APPLICATION

RE: Percolation Test Results
Application # A510195
Proposed Use: Subdivision
Day Road
Tax Map: 9 Parcels: 150 & 175

PERC CERTIFICATION PLAT

DELIGHTFUL DAZE (DAY ROAD)

PERC CERTIFICATION PLAT

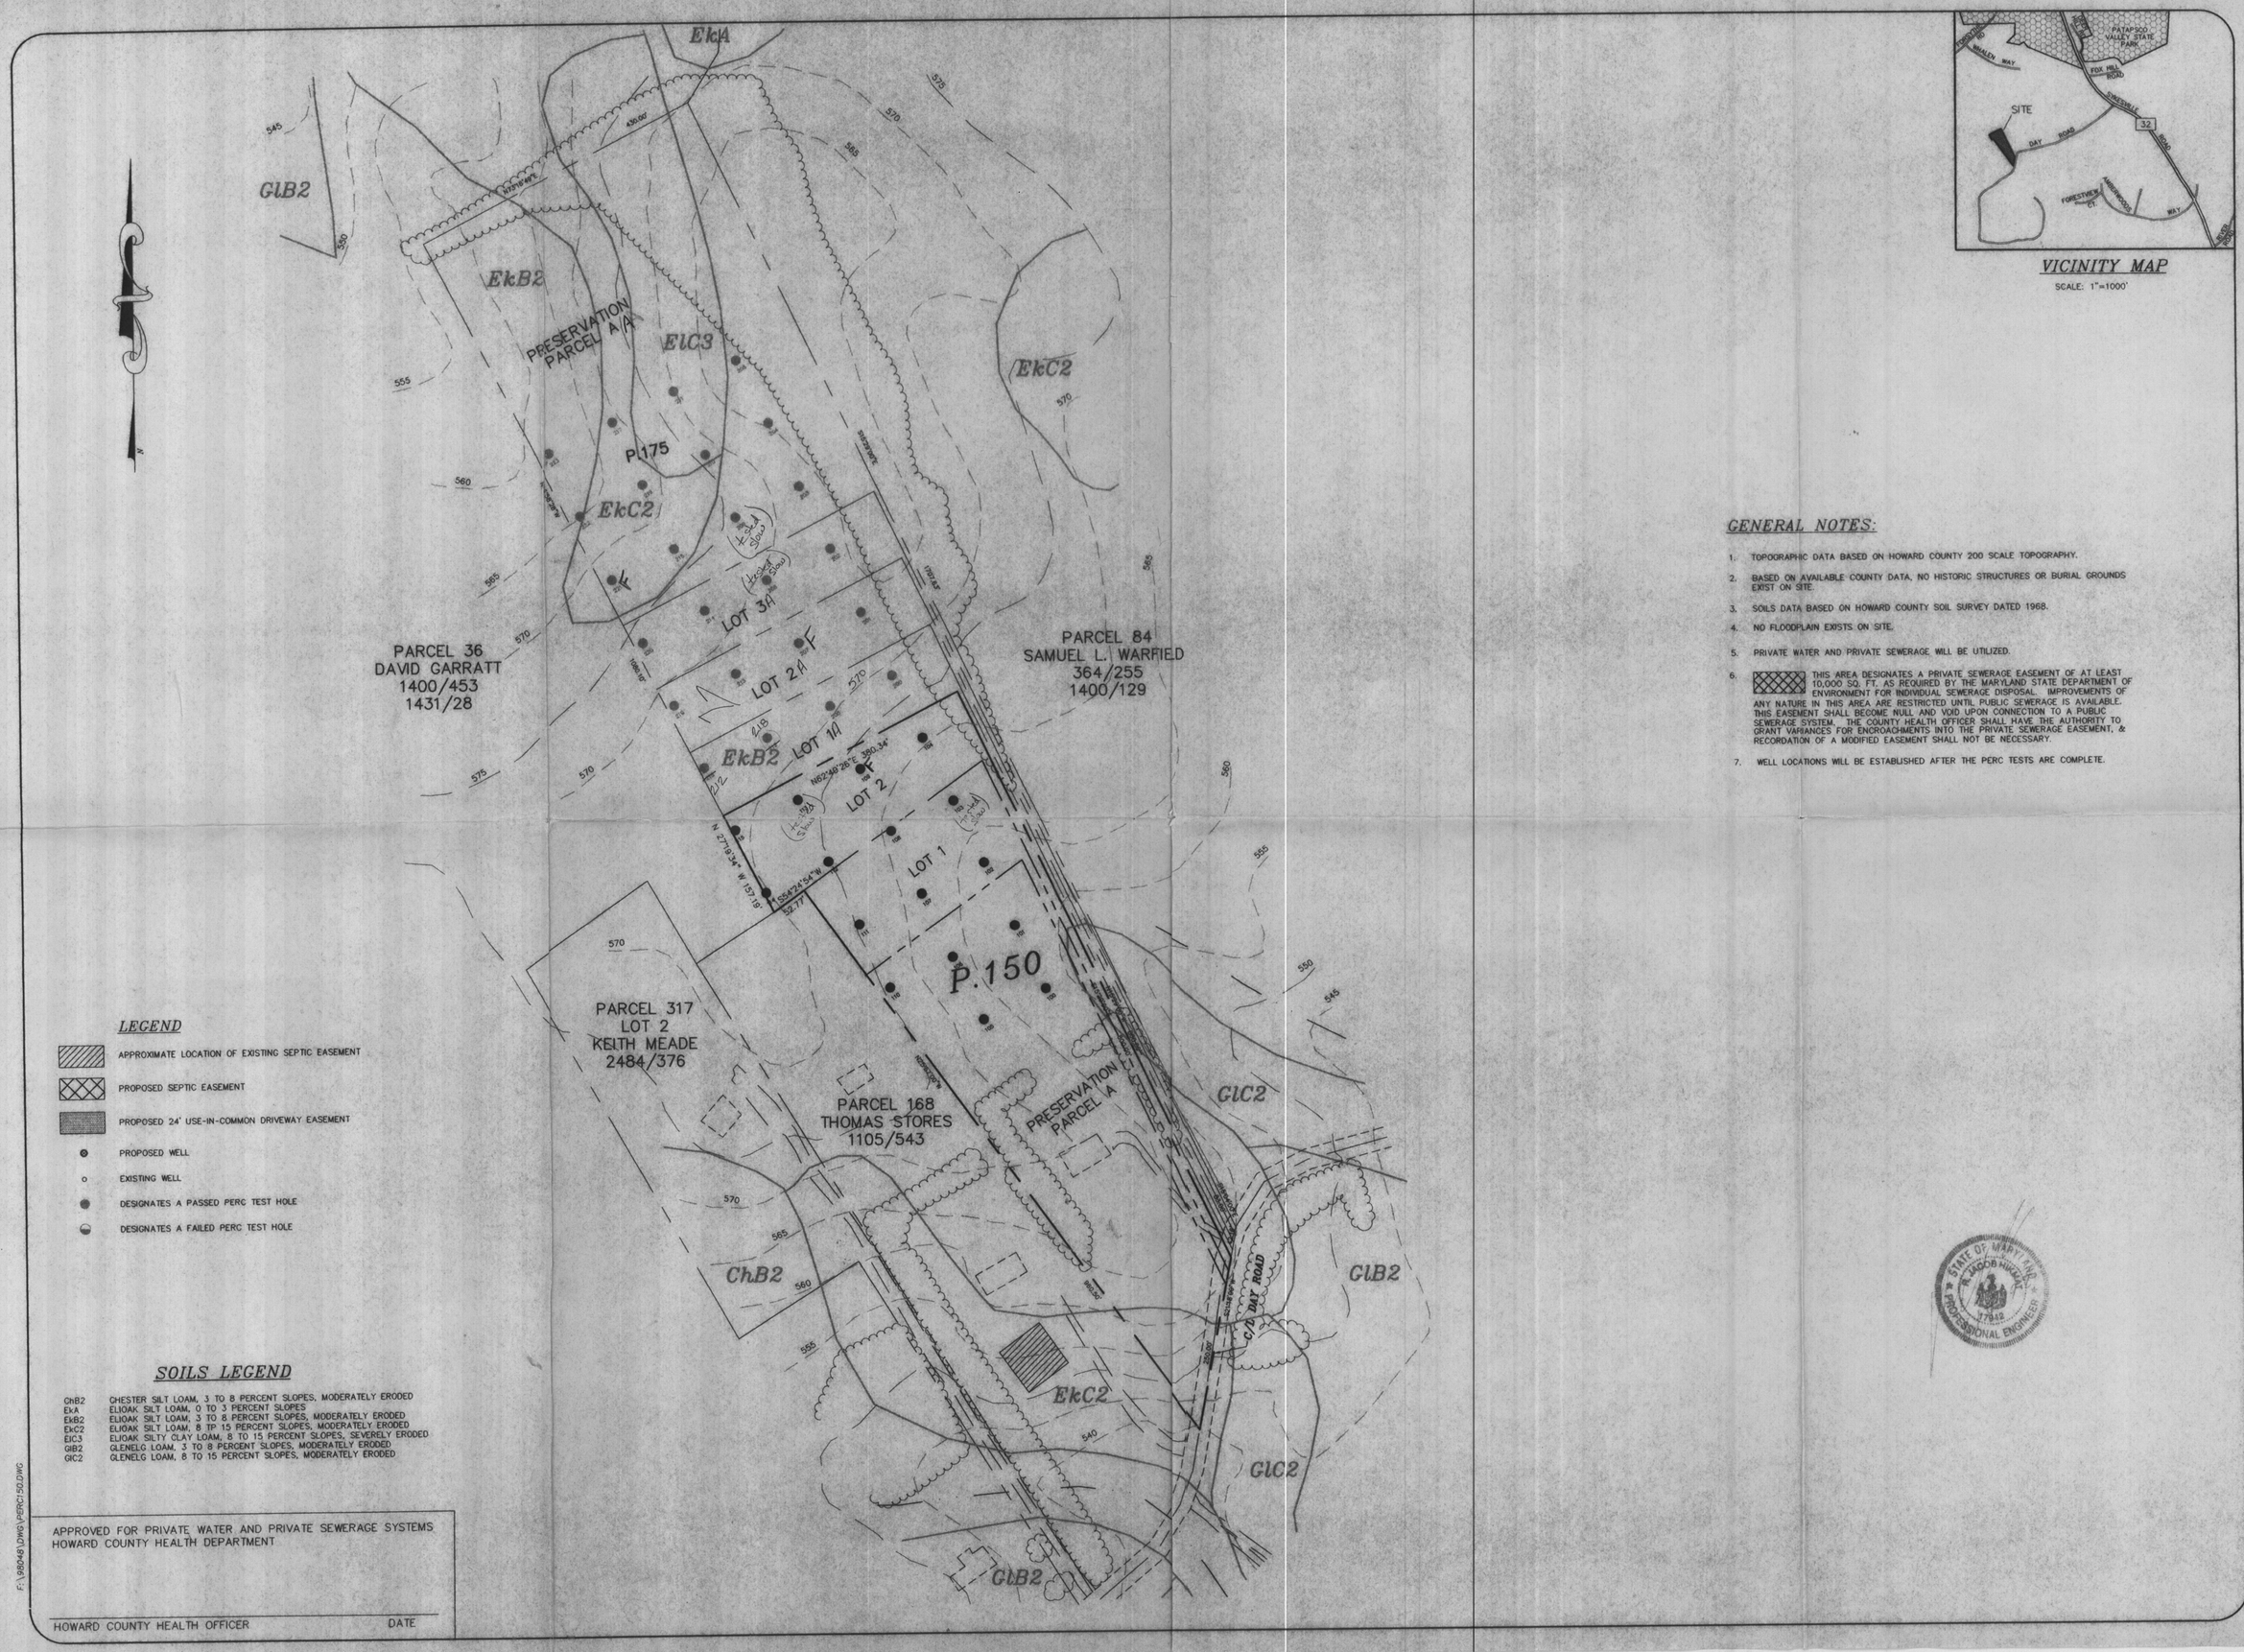
12-15-98
Revised perc test plat due to reconfiguration of septic area on Lot 2 (KM)

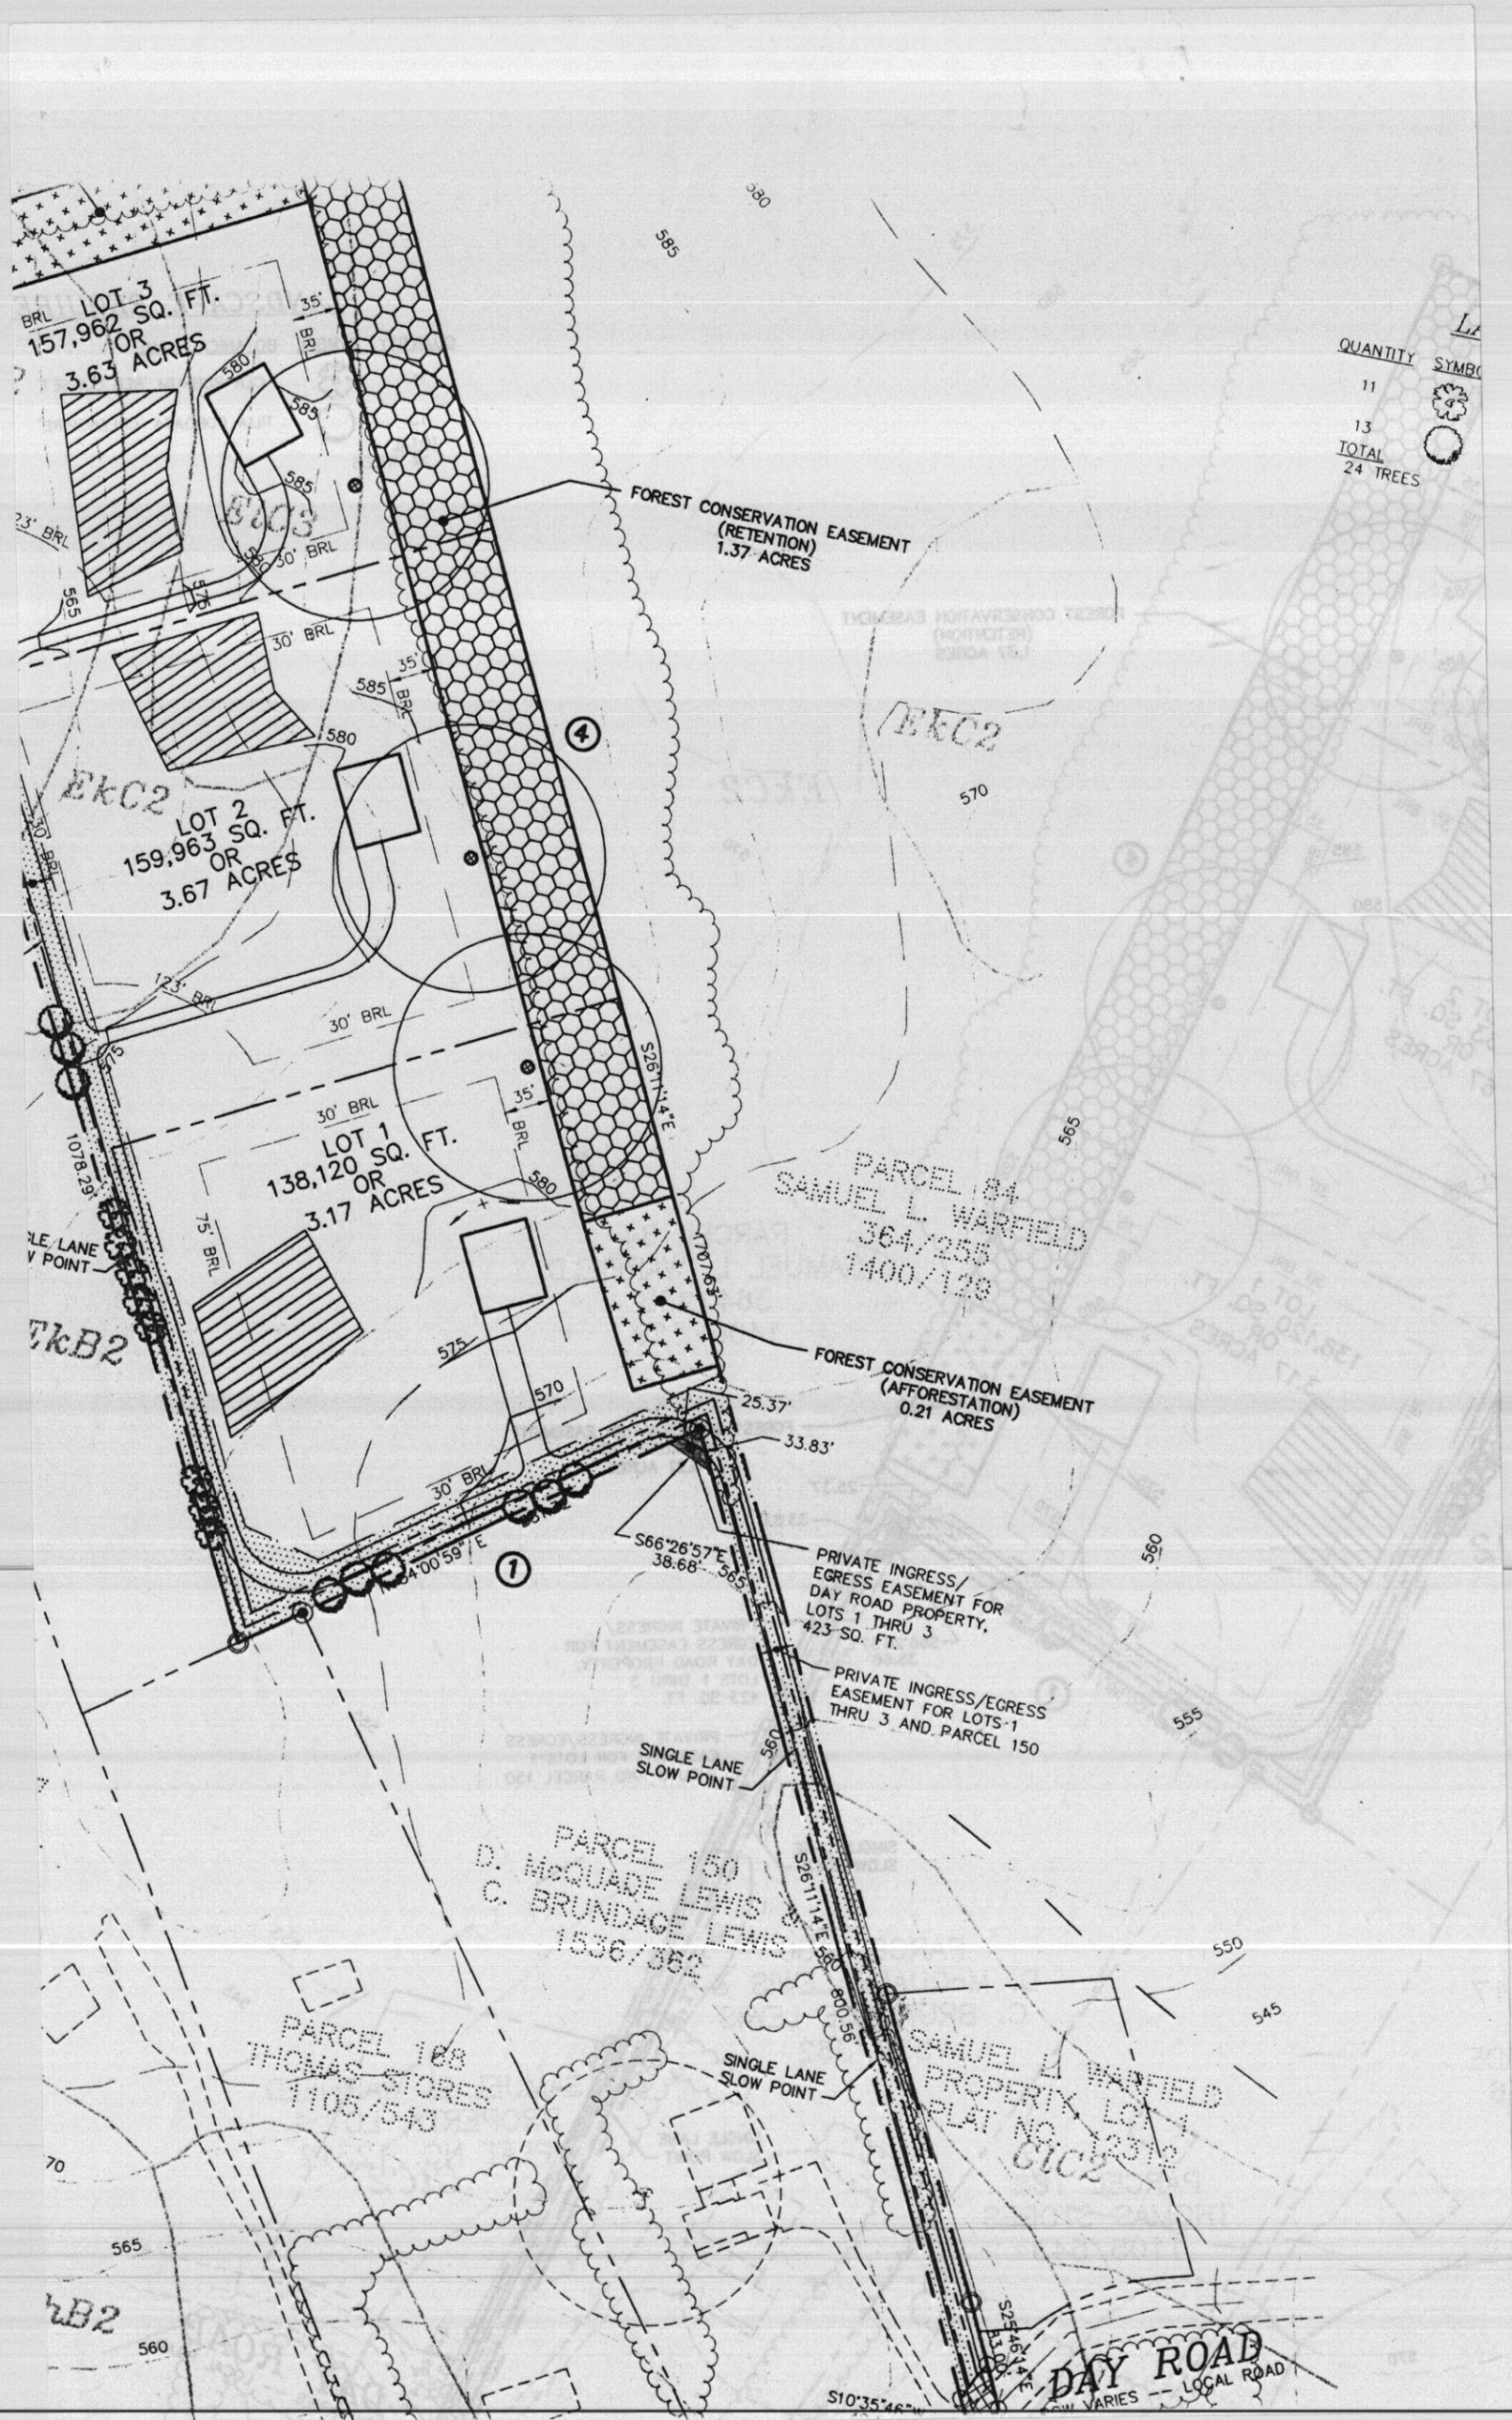
Existings trees which are to be preserved please try and not to encroach. I know it's tight!
